DART AEROSPACE LTD		Work Order:	79667
Description: Crosstube Assembly, Mid Aft		Part Number:	D206-667-247TRN
Inspection Dwg: D206-667-247 Rev: A		Page 1 of 1

DART AEROSPACE LTD HAWKESBURY, ONTARIO, CANADA	
DRAWING NO. D206-667-247	REV. A SHEET 1 OF 4
TITLE CROSSTUBE ASS'Y (206L MID AFT)	SCALE NTS
COPYRIGHT © 2010 BY DART AEROSPACE LTD. THIS DOCUMENT IS PRIVATE AND CONFIDENTIAL AND IS SUPPLIED ON THE EXPRESS CONDITION THAT IT IS NOT TO BE USED FOR ANY PURPOSE OR COPIED OR REPRODUCED IN ANY MANNER WITHOUT WRITTEN PERMISSION FROM DART AEROSPACE LTD.

DRAWING NO. D206-667-247	TITLE CROSSTUBE ASS'Y (206L MID AFT)	REV. A	DART AEROSPACE LTD ENGINEERING ORDER		D.E.O. NO. D206-667-247-A-1	SHEET NO. SHEET 1 OF 1	SCALE NTS
DRAWN <i>q2</i>	CHECKED <i>ASS</i>	MFG. APPR. <i>KB</i>	APPROVED <i>JMP</i>		DE APPR. <i>#</i>		
DATE 11.07.15	DATE 11.07.20	DATE 11.07.21	DATE 11/07/21		DATE 11.07.21

REPLACE MAGNOBOND WITH PROSEAL.

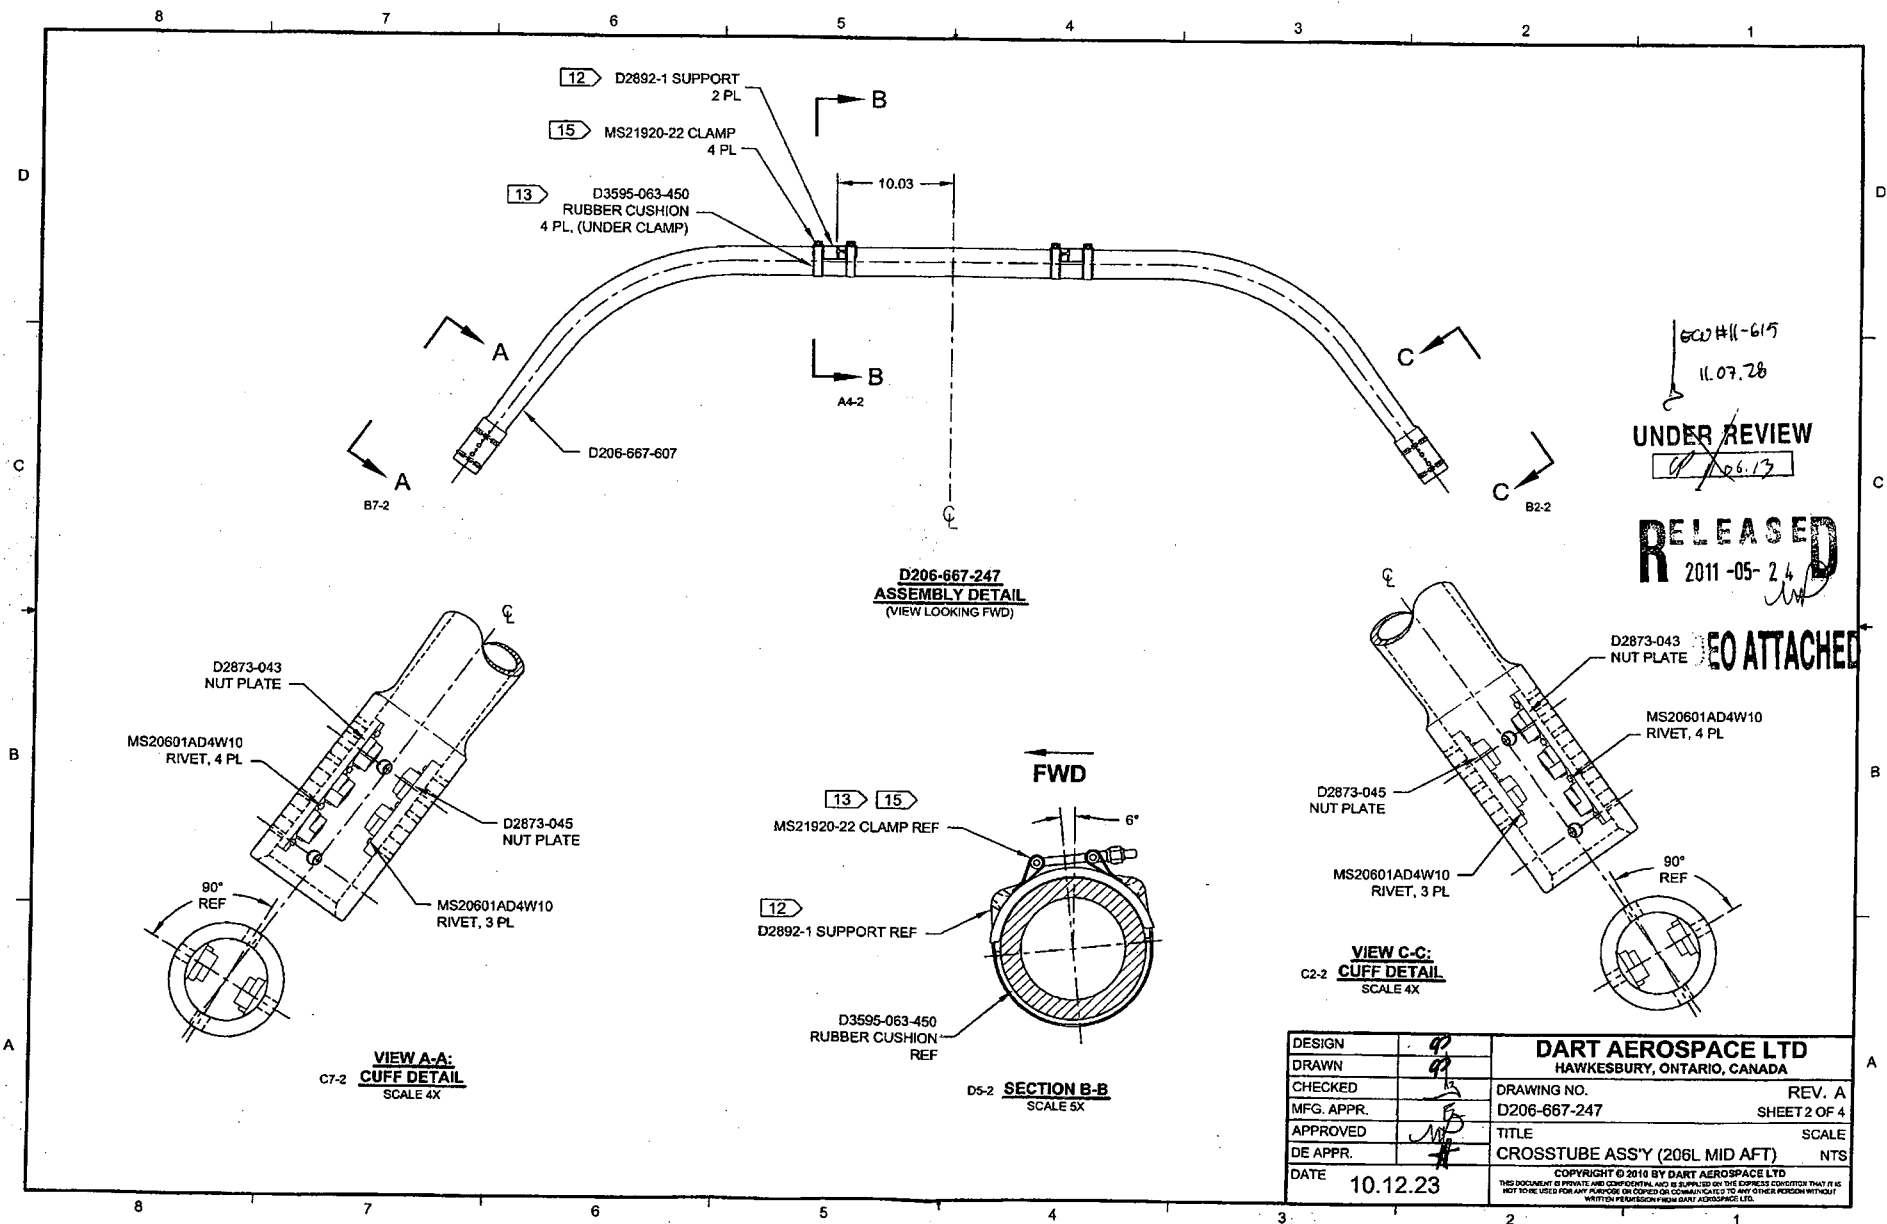
NOTE 12 & 15, SHEET 1 IS AMENDED AS FOLLOWS:

- 12) INSTALL D2892-1 SUPPORT USING 0.03" TO 0.06" THICK LAYER OF MAGNOBOND 6398 PER QSI 015. LET CURE FOR 12 HOURS AFTER INSTALLATION AND PRIOR TO PACKAGING.
- 15) TORQUE CLAMPS 80 TO 100 IN-LB. ENSURE AT LEAST 1.5 THREADS SHOWING IN SAFETY AND THAT NUT HAS NOT BOTTOMED-OUT AFTER TORQUING.

- 12) TO INSTALL D2892-1 SUPPORT: ABRASE MATING SURFACE OF SUPPORT AND CROSSTUBE WITH 180-GRIT SANDPAPER AND REMOVE RESIDUE WITH MEK (OR EQUIVALENT). APPLY A 0.04" TO 0.07" THICK LAYER OF PROSEAL 890 CLASS B-2 (OR AMS-S-8802 CLASS B-2) SEALANT TO MATING SURFACE OF SUPPORT.
- 15) TORQUE CLAMPS 80 TO 100 IN-LB. ENSURE AT LEAST 1.5 THREADS SHOWING IN SAFETY AND THAT NUT HAS NOT BOTTOMED-OUT AFTER TORQUING. **PRIOR TO PACKAGING, RE-CHECK TORQUE ON CLAMPS AFTER PROSEAL 890 SEALANT HAS CURED FOR 72 HOURS.**
